ADDENDUM NO. 3

RE: Downtown East Drainage Improvements – City of Stuttgart, Arkansas

ADDENDUM DATE: April 19, 2024

Sheets Revised: The following plans sheets have been revised and are attached to this addendum. These sheets are to be replaced in the overall sheet set. **Sheets 45-47 & 50-57.**

STORM PLAN
 9TH STREET

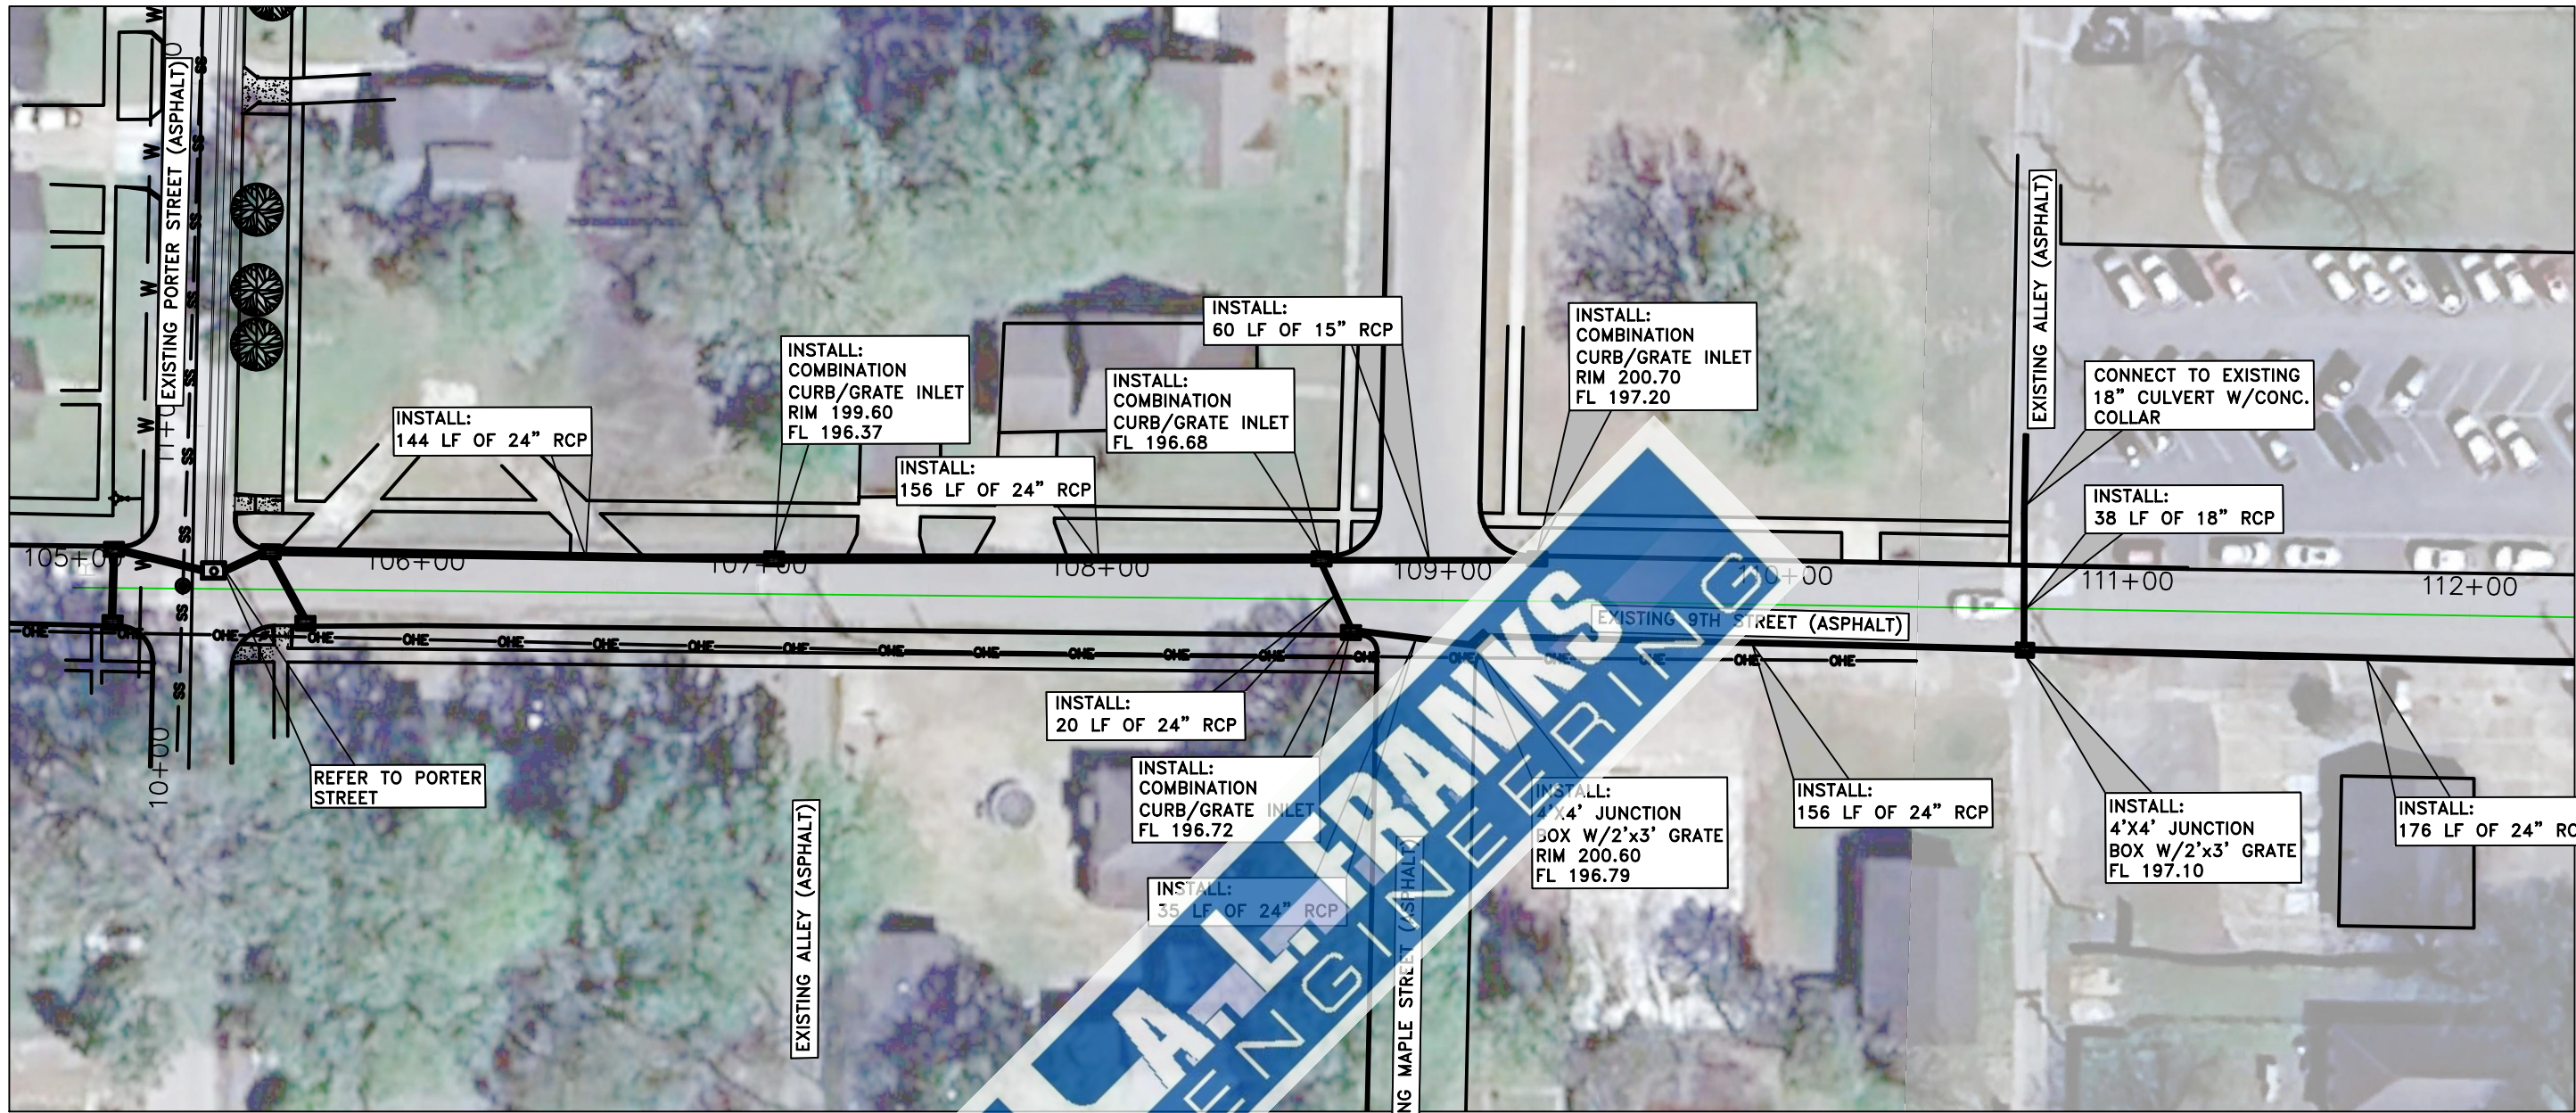
Date	Revision	By
4/18/24	1-Additional elevation data added	CJM

STORM PLAN
 9TH STREET

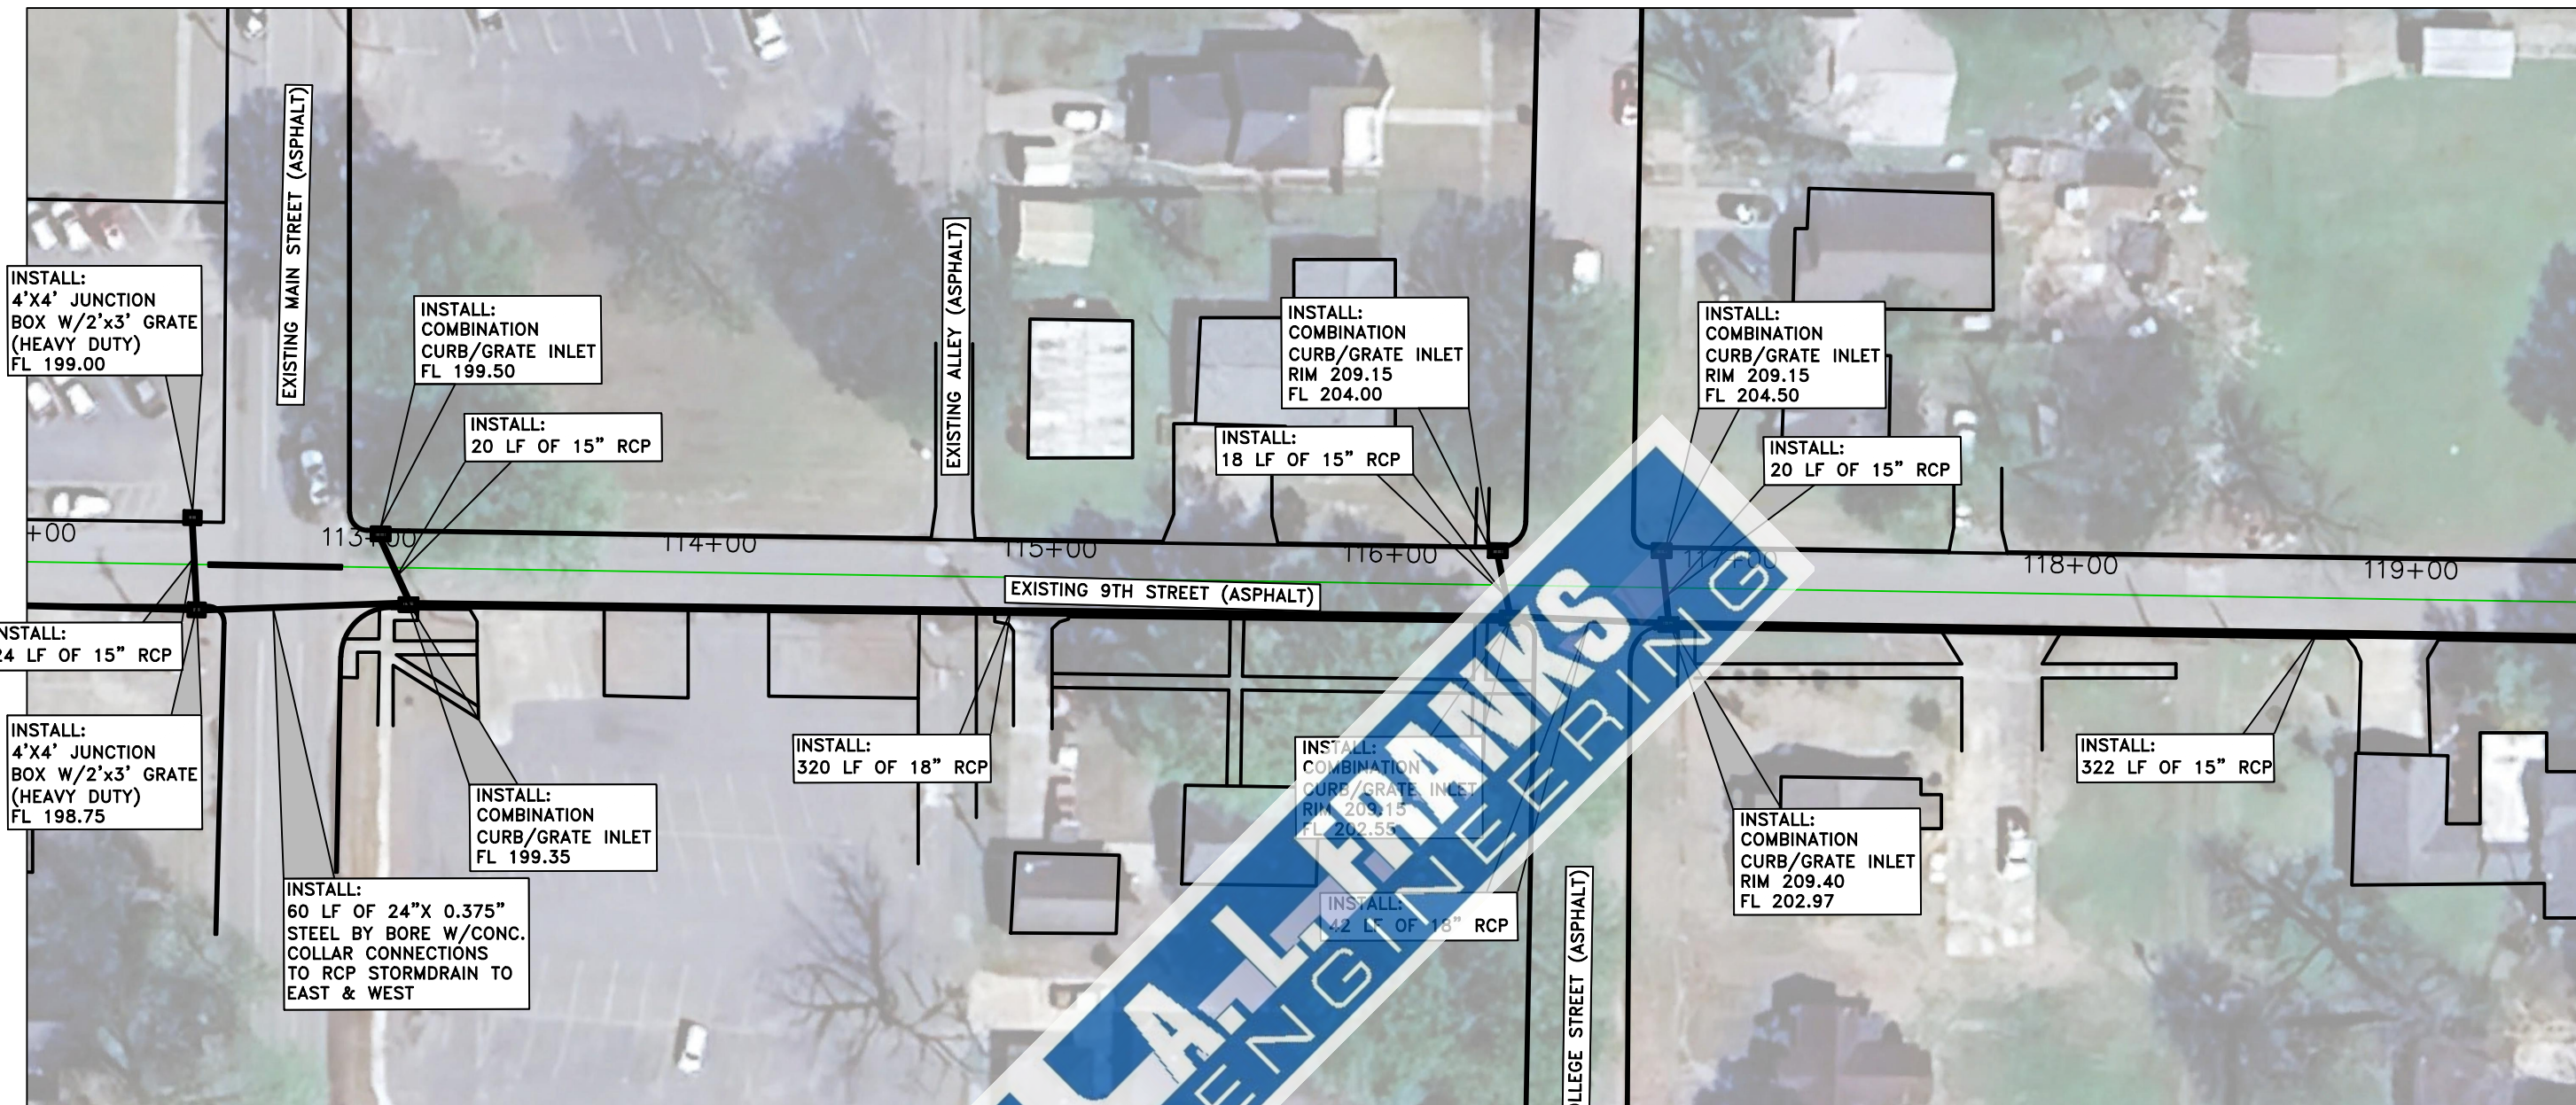
Date	Revision	By
4/18/24	1-Additional elevation data added	CJM

STORM PLAN
 9TH STREET

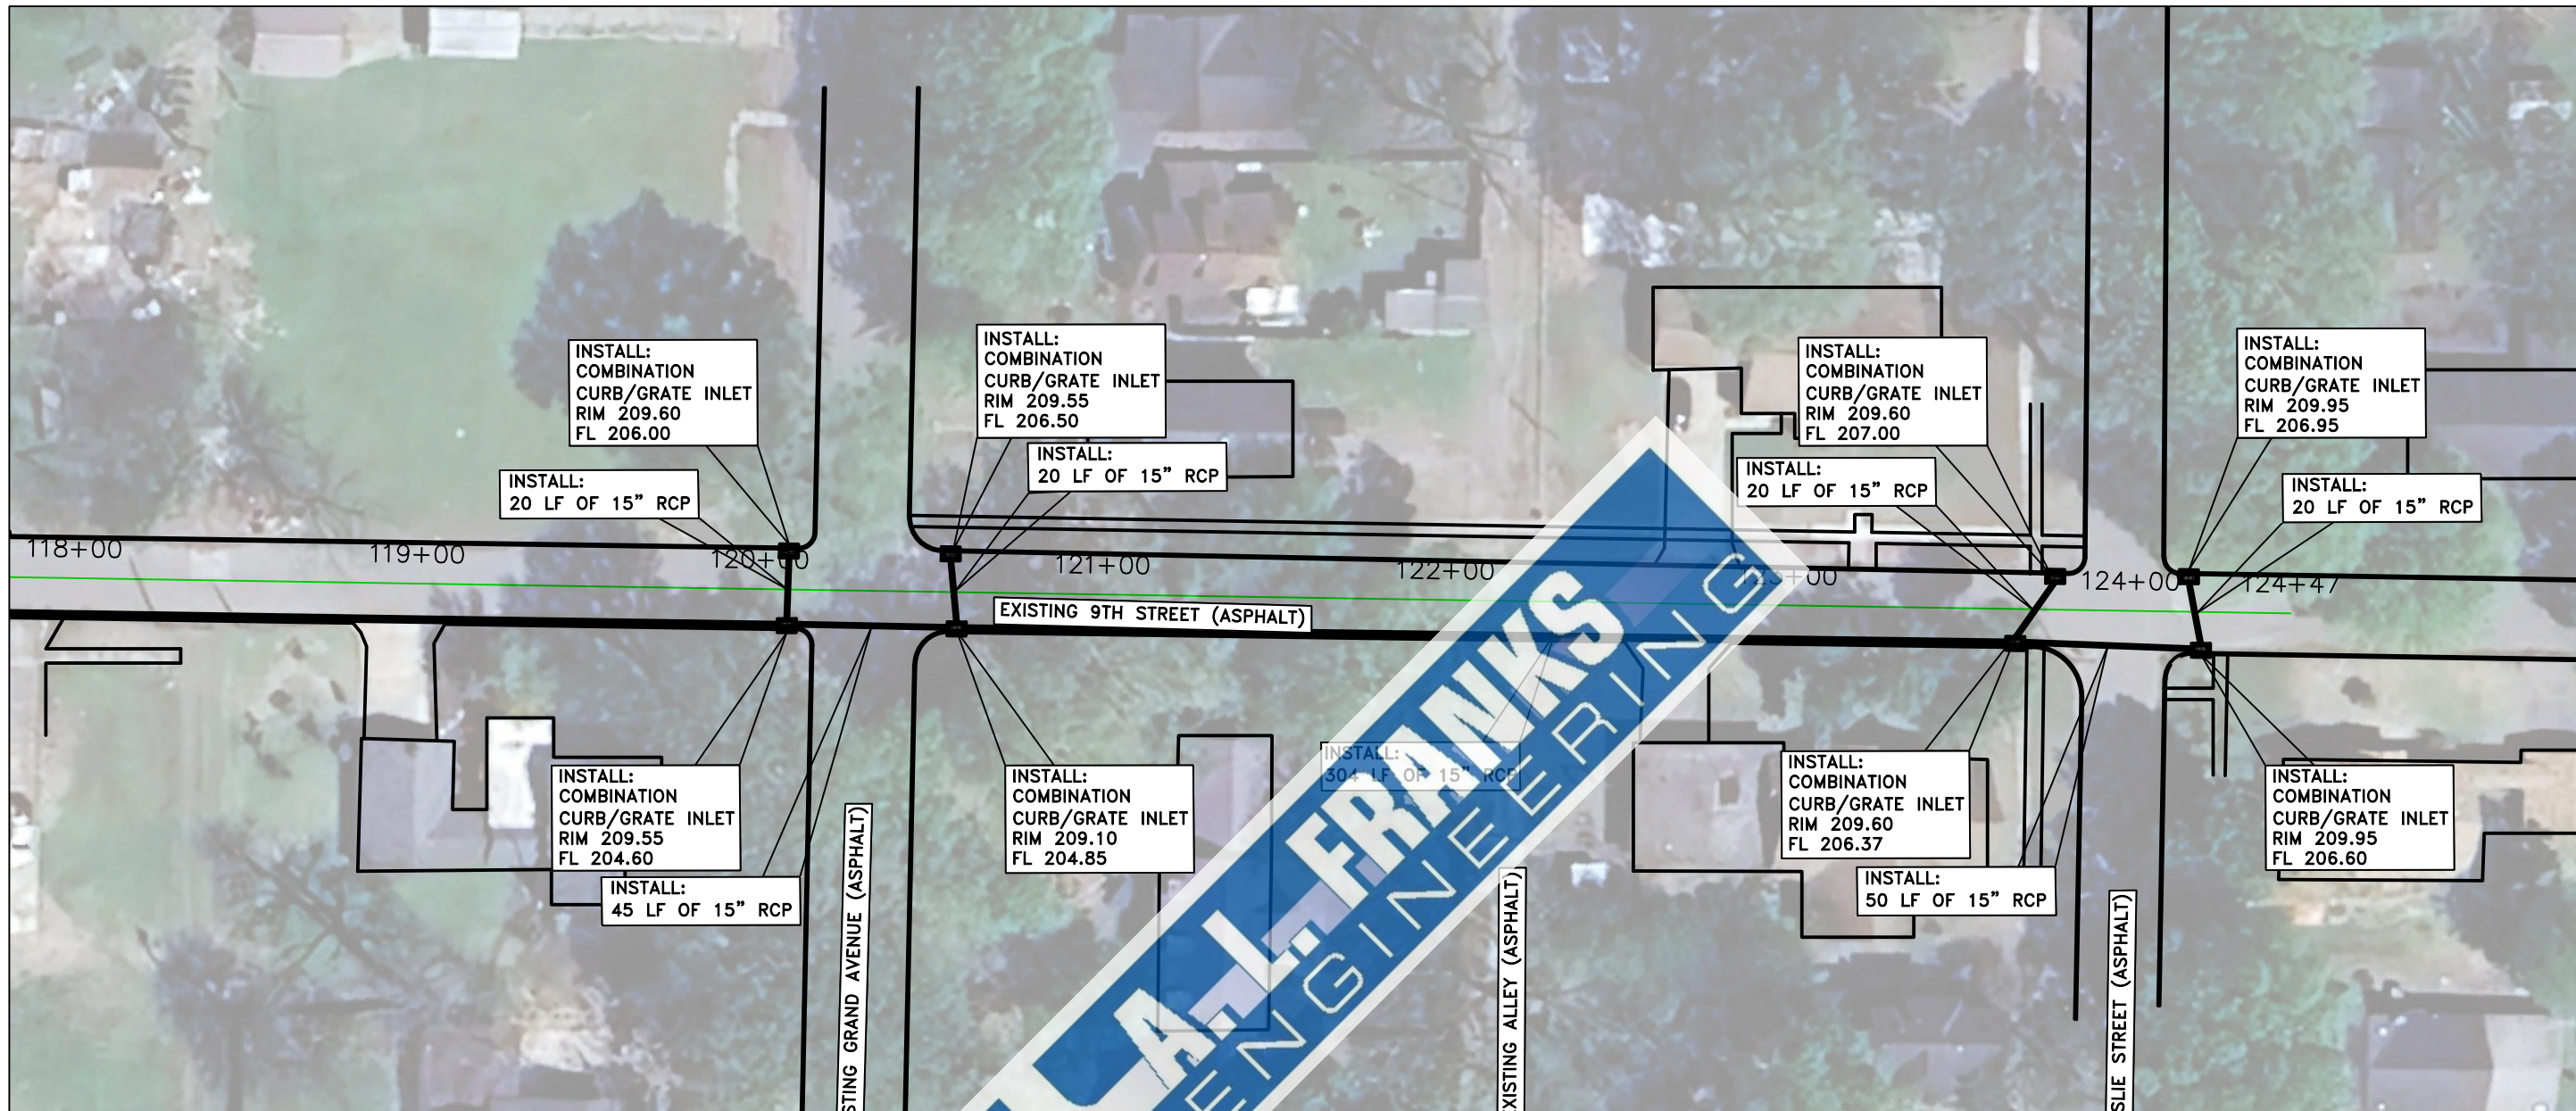
Date	Revision	By
4/18/24	1-Additional elevation data added	CJM
